JOINT REGIONAL PLANNING PANEL
(Sydney East)

JRPP No	2015SYE047
DA Number	15/22
Local Government Area	City of Botany Bay
Proposed Development	<p>Nominated Integrated Development Application, for a mixed use development comprising of:</p> <ul style="list-style-type: none"> • Demolition of existing structures; • Remediation of land; • Construction of a 14 storey mixed use building containing commercial and residential at ground floor and residential apartments above the ground floor, for a total of 184 apartments, with a proposed building height of approximately 45.5m above the existing ground level and a proposed floor space ratio of approximately 3.67:1; • Provision of a total of 268 car parking spaces, provided over 2 basement levels as well as at the western portion of the ground floor; • Ancillary works to facilitate vehicle access, drainage landscaping, and road widening; • Closure of existing vehicular access from Gardeners Road and construction of a temporary driveway connecting Bourke Street to the proposed basement car park. The driveway is in the location of the future New Road at the southern end of the subject site; • Land Subdivision to enable dedication of New Road to

Figure 8 Basement 1 Plan with the highlighted section depicting the approximate area identified on the Land Reservation Acquisition Map

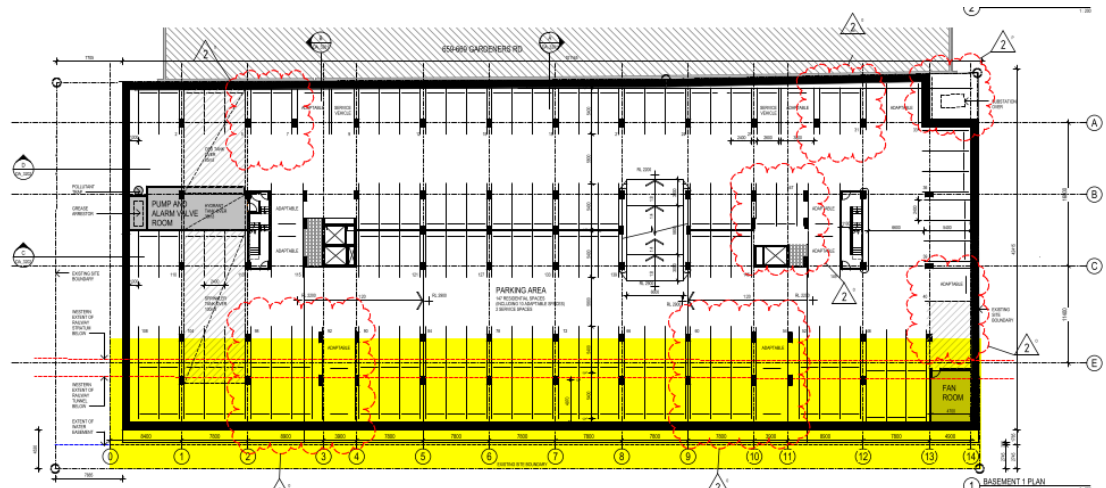
that concurrence could not be provided for the current proposal, given the works proposed within the area that is affected by the proposed classified road.

These works include part of the structure at each level of the proposed building. The images below indicate areas of different levels of the proposed building, which are affected by the LRA Map.
